**Seagate Technology**                      Tel: 405-324-3070  
10323 West Reno (West Dock)          Fax: 405-324-3794  
Oklahoma City, OK 73127-9705      gene\_milligan@notes.seagate.com  
P.O. Box 12313  
Oklahoma City, OK 73157-2313

9/6/2000

**Subject: Proposal for revision of the timing tables and definitions in SPI-4**

This proposal utilizes the timing budget already accepted into SPI-4 and completes the homework to use the timing budget as the basis for modifying the related timing tables, definitions, and figures. Revision two is the result of the working group meeting on 8/24/2000.

## Application of timing budget - skew block diagram with pre-compensation

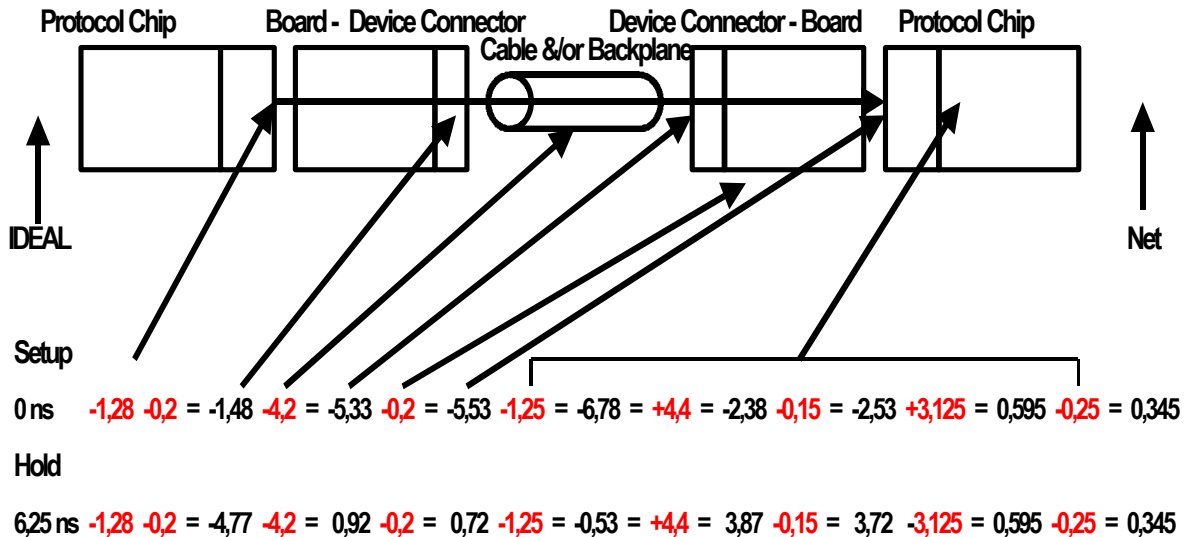
1) The transmitting SCSI device may reduce or increase the timing margin by the following worst case factors: bit period tolerance (i.e., REQ(ACK) Period Tolerance / 2); driver asymmetry; clock jitter; system noise at launch; pre-compensation; and board skew.

2) The transmission of data from one SCSI device to another may have the timing margin reduced by the signal timing skew that comprises the following worst case factors: crosstalk; cable skew; and ISI. If precompensation is invoked the worst case signal timing skew is reduced by the ISI compensation value. Portions of the crosstalk and ISI may also be observable at the transmitting device connector. Consequently transmit setup and transmit hold time should be measured with an alternating pattern at the negotiated data rate with all data signals other than that being measured held at a continual assertion or negation.

3) The reception of data within a SCSI device may have the timing margin reduced or increased by the following additional worst case factors: board skew; receiver amplitude time skew; receiver chip skew; receiver time asymmetry; system noise at the receiver; receiver chip noise (applied at receiver due to small signal physics); ISI compensation; skew compensation; strobe offset tolerance; and residual skew error.

## Application of timing budget - skew block diagram with post-compensation

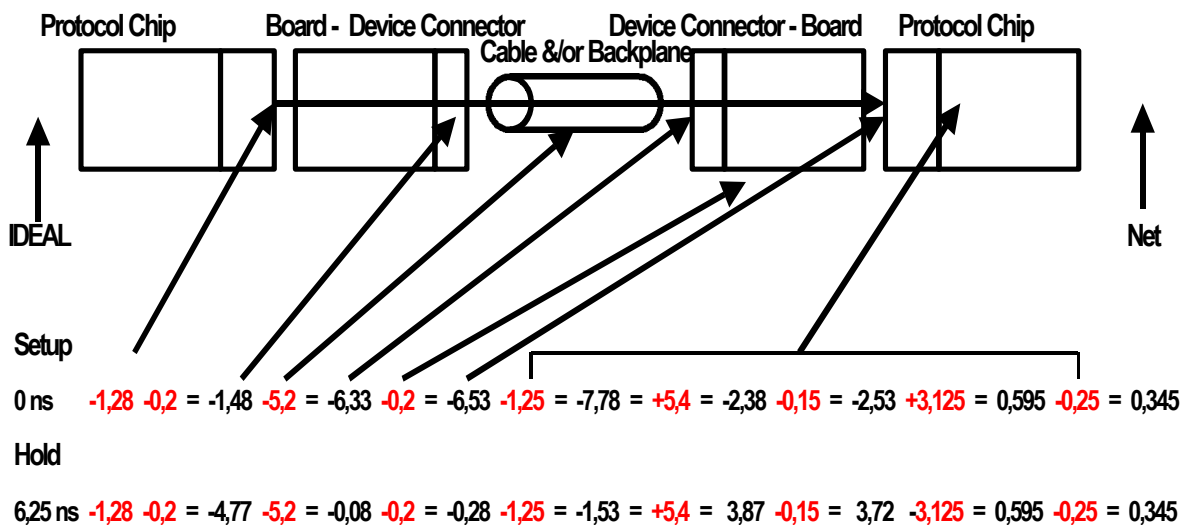
1) The transmitting SCSI device may reduce the timing margin by the following worse case factors: bit period tolerance (i.e., REQ(ACK) Period Tolerance / 2); driver asymmetry; transmitter chip skew, clock jitter; system noise at launch; and board skew.

2) The transmission of data from one SCSI device to another may have the timing margin reduced by the signal timing skew that comprises the following worse case factors: crosstalk; cable skew; and ISI. If precompensation is invoked the worse case signal timing skew is reduced by the ISI compensation value. Portions of the crosstalk and ISI may also be observable at the transmitting device connector. Consequently transmit setup and transmit hold time should be measured with an alternating pattern at the negotiated data rate with all data signals other than that being measured held at a continual assertion or negation.

3) The reception of data within a SCSI device may have the timing margin reduced or increased by the following additional worse case factors: board skew; receiver amplitude time skew; receiver chip skew; receiver time asymmetry; system noise at the receiver; receiver chip noise (applied at receiver due to small signal physics); ISI compensation; skew compensation; strobe offset tolerance; and residual skew error.
